Australian Resources Development Limited

Submission regarding AEMO's Draft 2026 Integrated System Plan

13 February 2026

Chart 1: Comparison of FY30 generation technology mixes of 26DISP with 25ESOO

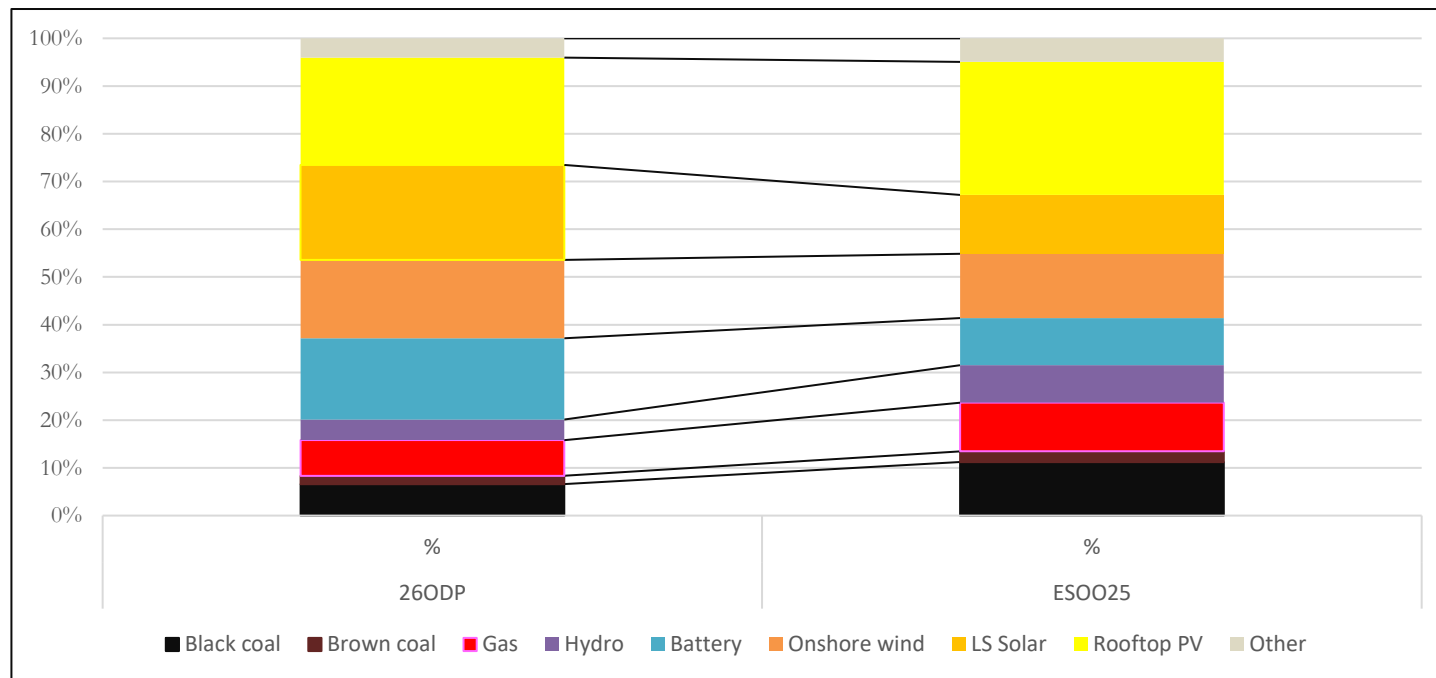
In this context, Chart 1 sets out the FY30 generation technology mixes for 26ODP and 25ESOO. The 25ESOO generation capacity⁴ was adjusted from typical summer availabilities to nameplate capacity for purposes of comparison. 2029-30 is the fifth year of the 25ESOO outlook and so, in the period when fewer developments are identified. It is also the year in which “... 82% of the NEM’s supply (will) be from renewable sources ...”. (26DISP, page 18).

The major differences between the FY30 generation technology mixes are:

- ❑ The 26DISP has approximately 20% dispatchable capacity (coal, gas and hydro) compared with approximately 30% for the 25ESOO.
- ❑ The 26DISP has approximately 60% onshore wind and LS Solar capacity compared with approximately 55% for the 25ESOO, while both use the same projections for Rooftop PV capacity.
- ❑ The 26DISP has approximately 17% of battery storage (which AEMO classes as dispatchable) compared with 10% for the 25ESOO.

Under the 26DISP mix, renewables generate precisely 82% of the load by using the significantly higher battery storage to firm the renewables. In contrast, the 25ESOO mix relies on 4GW more of dispatchable coal capacity and less battery storage and would not meet the 82% target.

Notwithstanding the more reliable generation mix based on committed and anticipated projects, the 25ESOO concludes that additional firm capacity is required to meet the reliability standards in FY30.

Thus, relative to the 25ESOO, the 26DISP bears little relationship to the developments in the NEM.

Change in electricity generation: H1-2025 v H1-2024 (TWh)

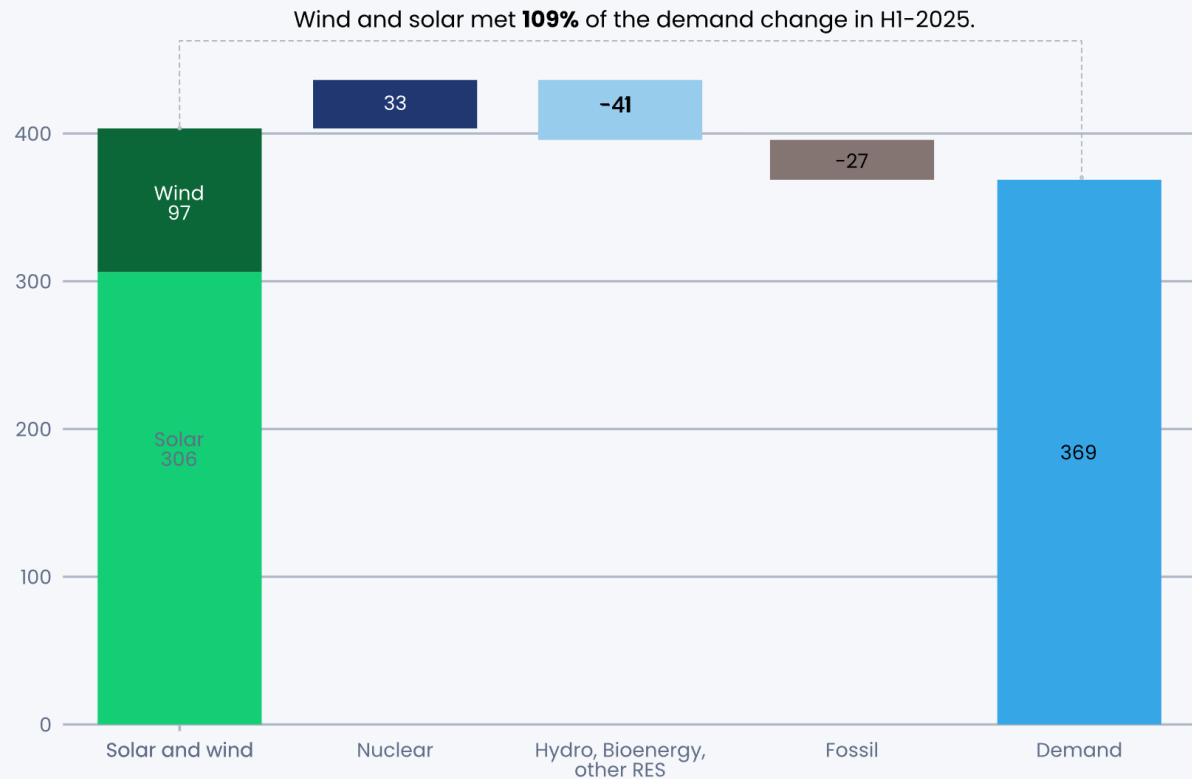
The statement is not a direct quotation from ER25 with the closest statement: “Solar and wind outpaced demand **growth** as renewables overtook coal’s share in the first half of 2025.” (Front page, emphasis added).

The total change in demand in H1 25 compared with H1 24 is 372TWh (slightly different from 369TWh set out in the chart reproduced in Appendix 2).
